SUBJECT: F410 RDH Finisher system duplex method change  
(manual corrections)

SUBJECT: F410 RDH Finisher system duplex method change  
(manual corrections)

SUBJECT: RDH Original Size Misdetection

SUBJECT: USER REMARKS WHILE SETTING THE ORIGINAL ON  
THE RDH

Fig 1

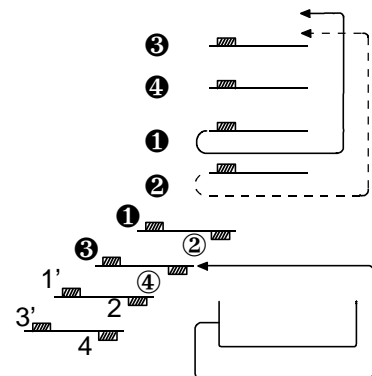
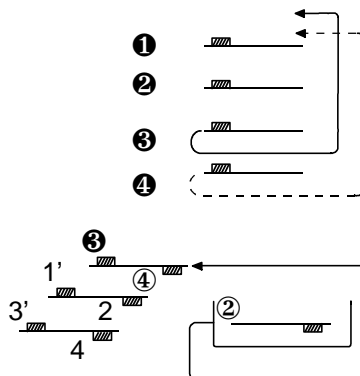
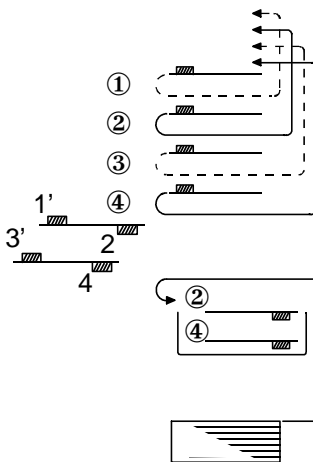
The following is the new method the F410 uses for copying 1 sided originals to 2 sided copies.

Please delete pages 14, 15, and 16 of the RDH section and insert the following explanation.

When making two-sided copies, first of all, the even pages of the originals placed on the RDH are copied to the paper from the paper tray. They are stored in the duplex tray. Then the originals are recirculated, and the odd pages of the originals are copied to the sheets stored in the duplex tray.

- 1) When the start key is pressed, the 4th and 2nd originals are scanned then these copies are stacked in the duplex tray. The 3rd and 1st originals have only passed over the exposure glass [Fig. 1].
- 2) Soon after the 1st recirculation is completed, the second recirculation starts. The 4th originals just passes the exposure glass then the 3rd original is scanned. This image is copied onto the copy which has been fed from the duplex tray and is then fed out onto the finisher [Fig. 2].
- 3) The 2nd original just passes the exposure glass and then the 1st original is scanned. The copy from the duplex tray is fed for copying the 1st original and then fed out onto the finisher. At this moment, the duplex tray becomes empty [Fig. 3].
- 4) The following steps repeat steps 1) to 3). [Fig. 4] to [Fig. 6].

DATE: Jan. 31,'94  
PAGE: 9 of 13**Page 6-19 1.15**

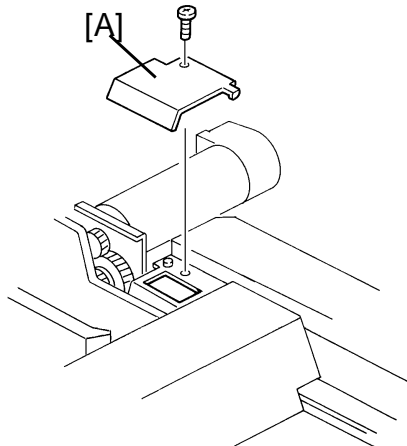
- Incorrect

**1.15 DUAL JOB FEEDER**

Encoder pulse is not detected by the DJF main board.....

DJF feed motor defectiveDJF transport motor defectiveDJF feed out motor defectiveDJF inverter motor defective

- Correct

**1.15 DUAL JOB FEEDER/RECIRCULATING DOCUMENT HANDLER**

Encoder pulse is not detected by the DJF/RDH main board.....

DJF/RDH feed motor defectiveDJF/RDH transport motor defectiveDJF/RDH feed out motor defectiveRDH inverter motor defective

### REASON OF THE MISDETECTION

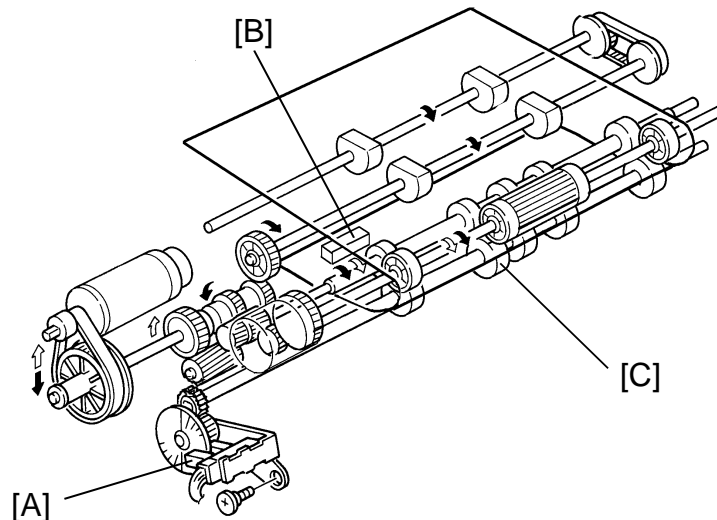
Original length is detected by the pulse generator sensor [A]. the RDH counts pulses from the point where the leading edge of the original activates the registration sensor [B] until the trailing edge of the original de-activates the registration sensor. The pulse count is compared with the reference data which is stored in the ROM to judge the original size.

The pulse generator wheel is driven by the driven pull-out roller [C].

From October to November 1993 production, grease was applied to the four driven roller shaft holders. When this grease on the shaft holders is contaminated with paper dust, it increases the mechanical load to the driven pull- out roller shaft resulting in the slippage between this roller and the original.

Due to the slippage, the pulse count varies. Because of this pulse variation, it is possible that the RDH detect the original length incorrectly.

**FIELD MACHINE COUNTERMEASURE**

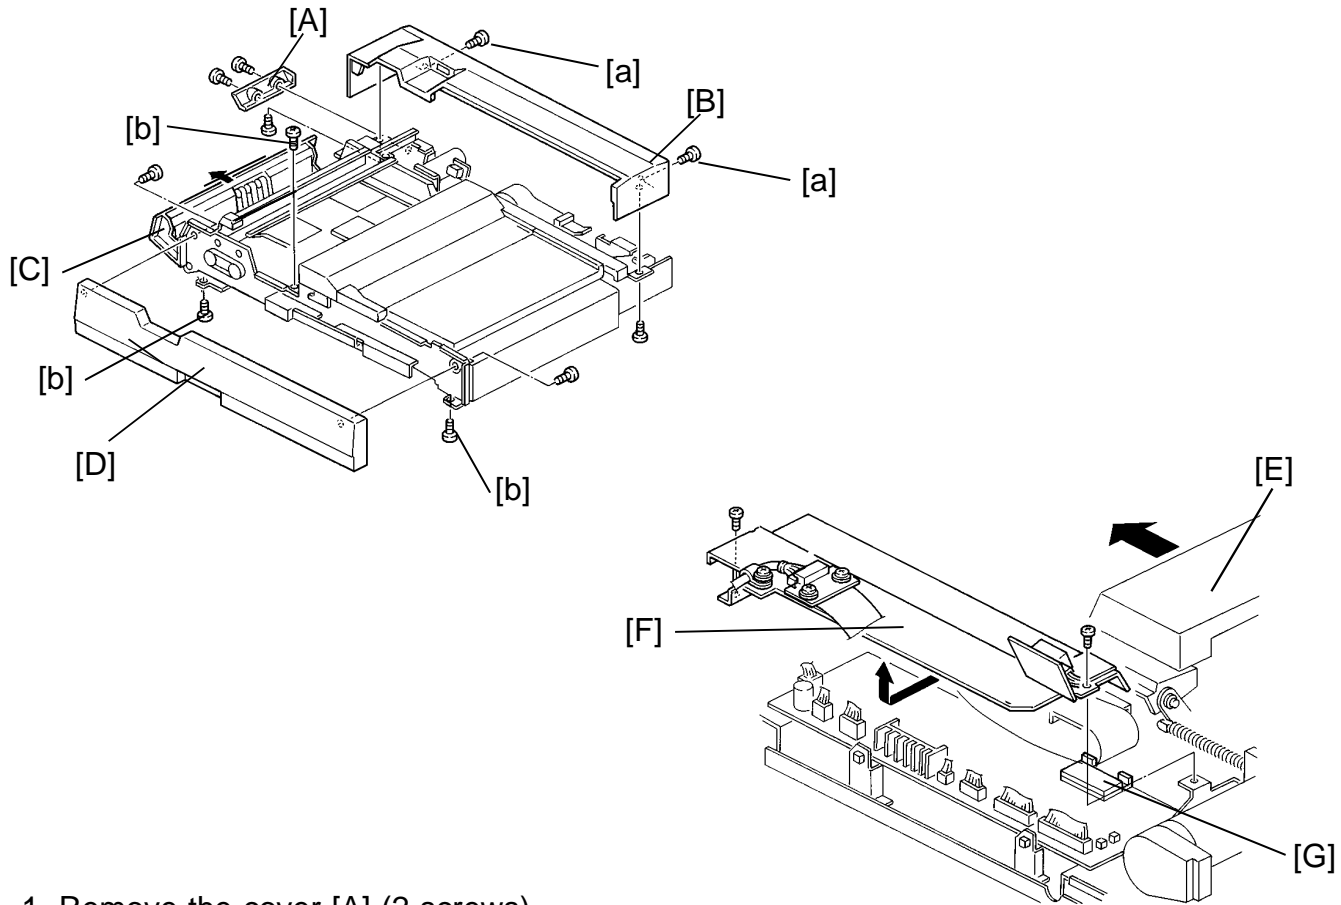
Change the ROM on the RDH main board from A3785810C or A3785810D to A3785810F.

Clean the driven pull-out roller shaft with alcohol.

Replace the four driven pull-out roller holders.

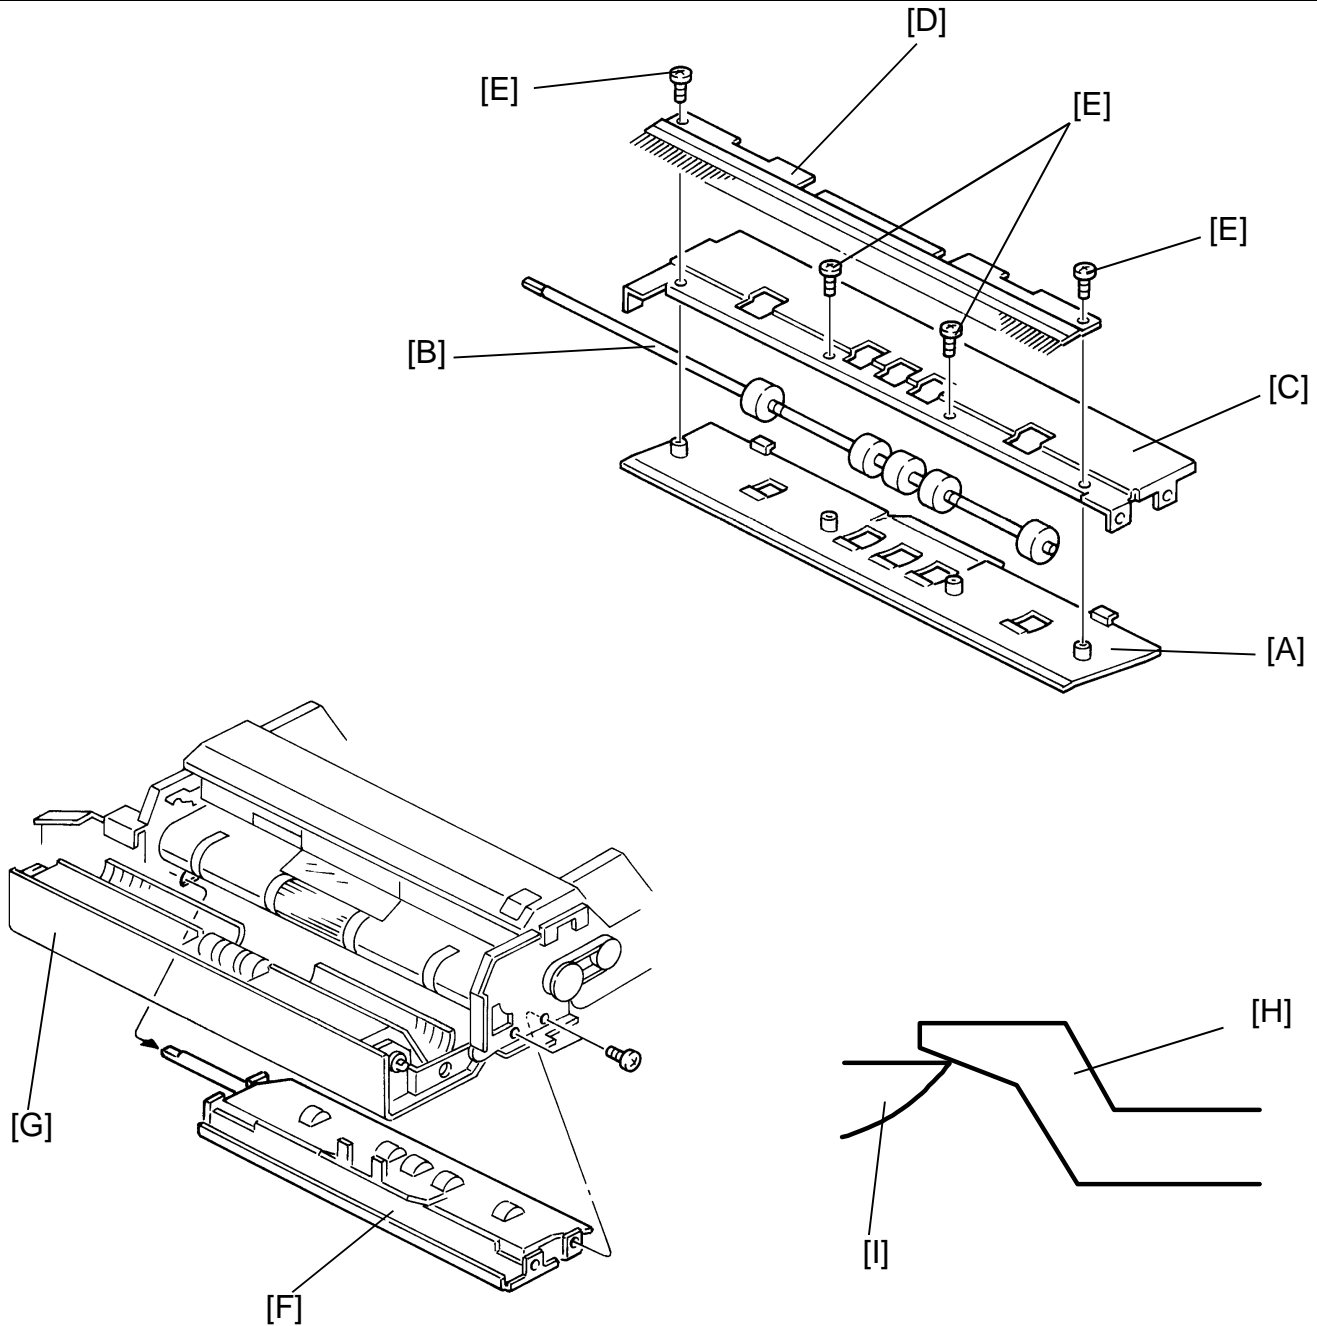
21. Completely wipe off the grease on the pull out roller shaft [A] with alcohol.
  22. Remove inner springs (Silver) [B] and outer springs (Black) [C].
  23. Replace 4 arms [D] (1 screw each).
  24. Install inner springs (Silver) [B] and outer springs (Black) [C].
- NOTE:** Inner springs and outer springs are different, do not mix them.

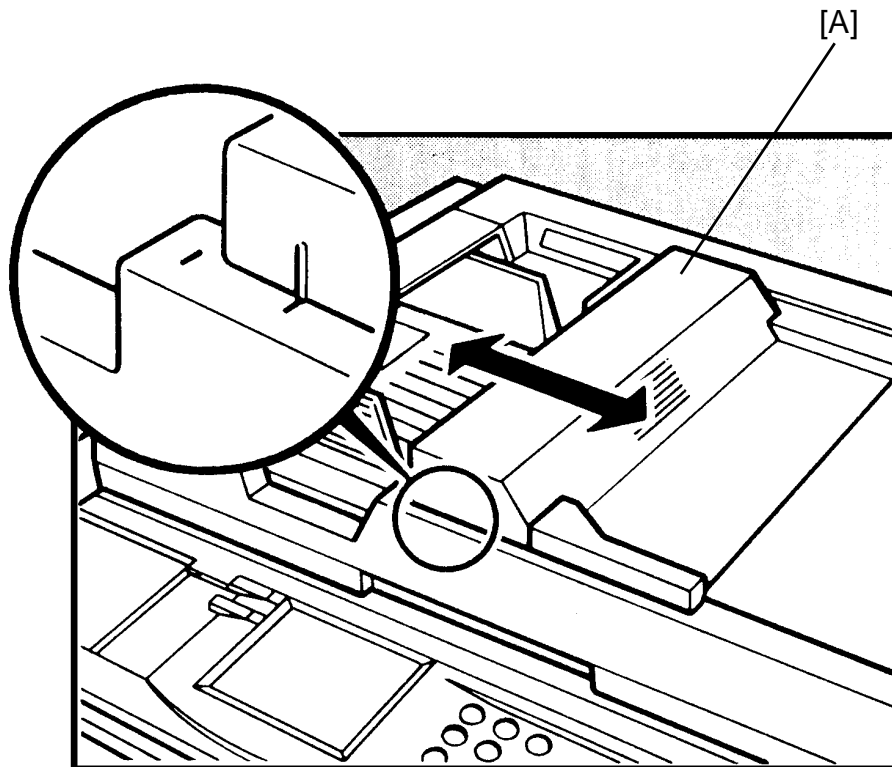
During field survey, we found cases that an incorrect feed out unit position created original jams.

Please instruct the customer to set the feed out unit in the correct position.

*To prevent original jams,  
slide the feed-out unit [A] to match the size marks on  
the front of the recirculating document handler (RDH).*
